SPARC Enterprise M3000/M4000/M5000/ M8000/M9000 Servers

Product Notes for XCP Version 1123

Manual Code: C120-0062-02EN
December 2017, Revision A

M9000 Servers Installation Area

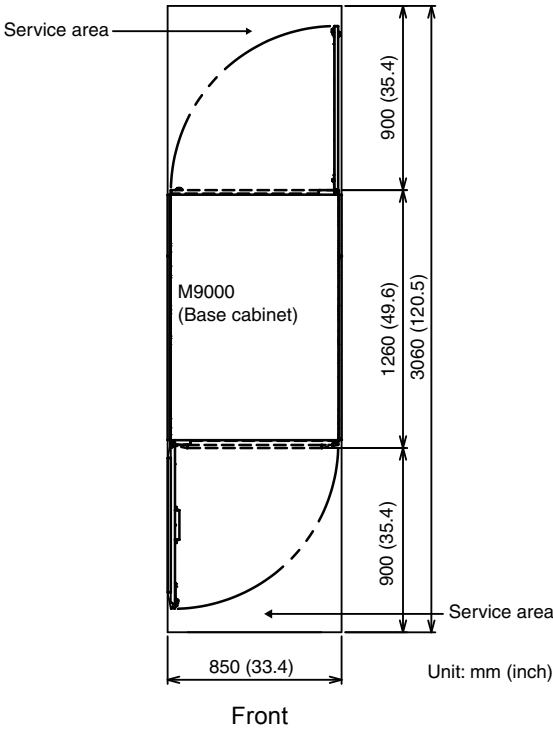
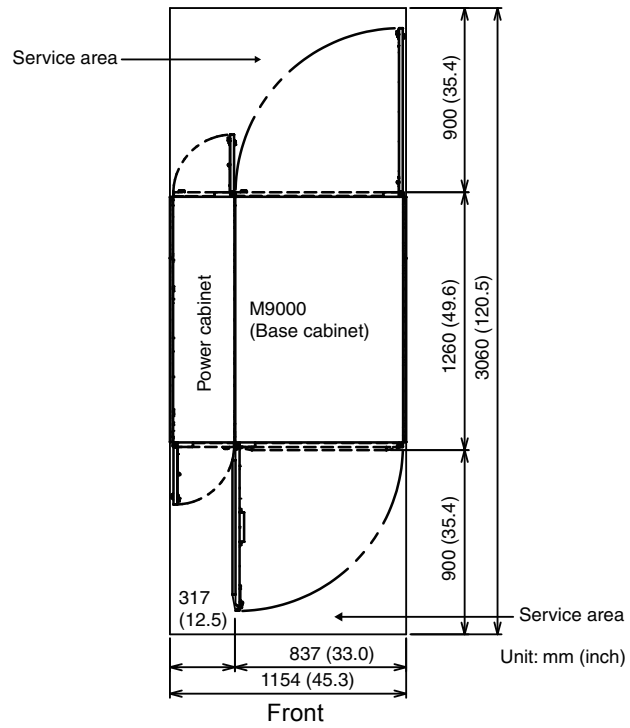
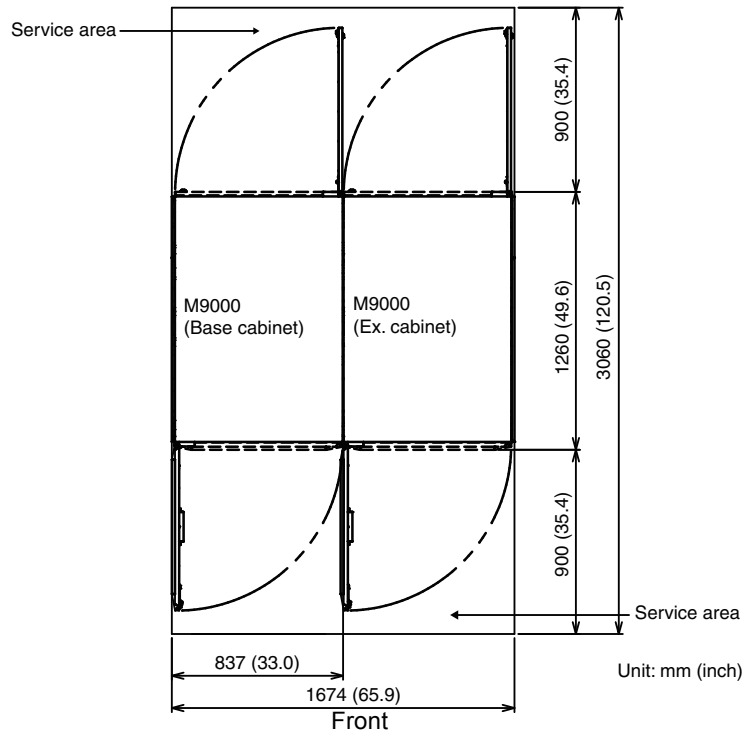
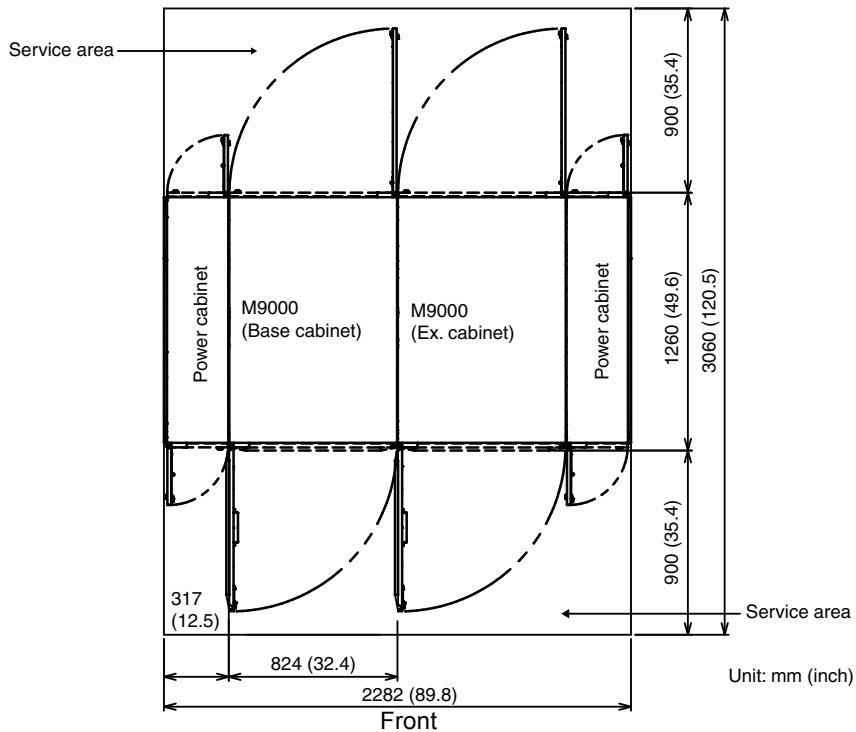
SPARC Enterprise M8000/M9000 Servers Site Planning Guide	1-18	A part of values in inches on FIGURE 1-13 to FIGURE 1-16 will be corrected. For detail, see “M9000 Servers Installation Area” on page 123.
	1-35	For the order number of Vibration-proof bracket and Vibration-proof feet, see “Miscellaneous Information” on page 127.
SPARC Enterprise M8000/M9000 Servers Service Manual	7-8	The mounting location of I/O Unit (IOU) indicated on FIGURE 7-4 will be corrected. For detail, see “I/O Unit (IOU) Mounting Locations” on page 126.”

The following information supersedes the information in the *SPARC Enterprise M8000/M9000 Servers Site Planning Guide*
